Project	IEEE 802.16 Broadband Wireless Access Working Group < http://ieee802.org/16 >
Title	NCMS Initiated Idle Entry
Date Submitted	2006-11-12
Source(s)	Peretz Feder - Lucent Technologies [mailto: pfeder@lucent.com]
Re:	
Abstract	Adding the missing NCMS initiated Idle entry
Purpose	Adoption
Notice	This document has been prepared to assist IEEE 802.16. It is offered as a basis for discussion and is not binding on the contributing individual(s) or organization(s). The material in this document is subject to change in form and content after further study. The contributor(s) reserve(s) the right to add, amend or withdraw material contained herein.
Release	The contributor grants a free, irrevocable license to the IEEE to incorporate material contained in this contribution, and any modifications thereof, in the creation of an IEEE Standards publication; to copyright in the IEEE's name any IEEE Standards publication even though it may include portions of this contribution; and at the IEEE's sole discretion to permit others to reproduce in whole or in part the resulting IEEE Standards publication. The contributor also acknowledges and accepts that this contribution may be made public by I

1 **Section 14.2.5.2**

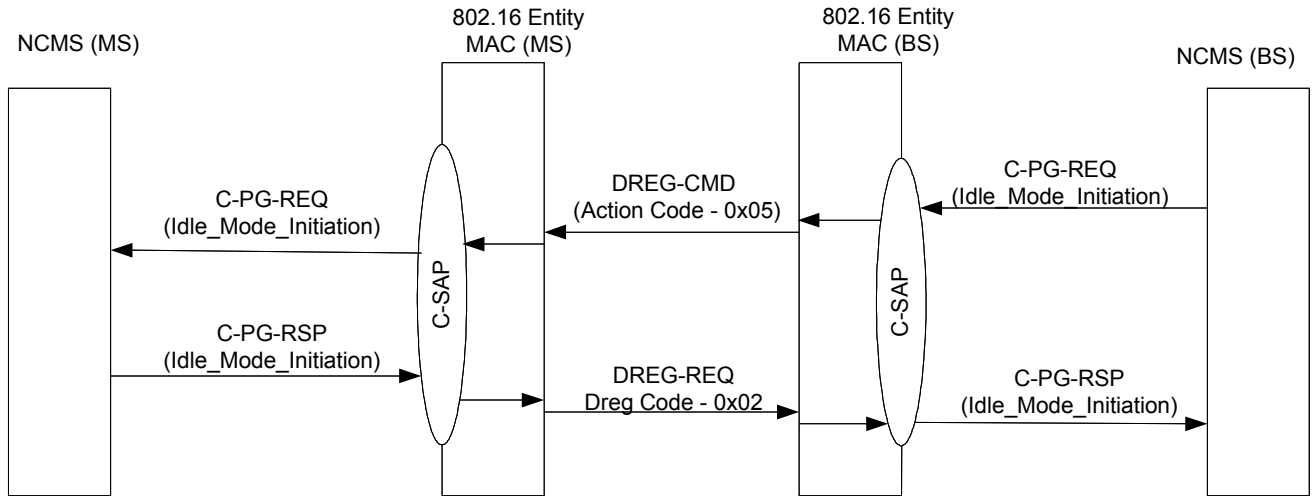
Text and Figure are added to cover the case where the NCMS through the BS commands the MS to enter Idle mode in unsolicited manner and the MS sends a DRG-REQ message with a Dregistration Request code =0x02.

3 **Add the following figure in this section:**

7 This primitive is issued by BS to inform a management entity of Paging Services in NCMS that an MS requests to initiate
 8 Idle Mode. **This primitive can also be issued by the NCMS to force MS into an Idle mode by instructing**
 9 **the BS to initiate a DREG-CMD to the MS with Action Code = 0x05.**
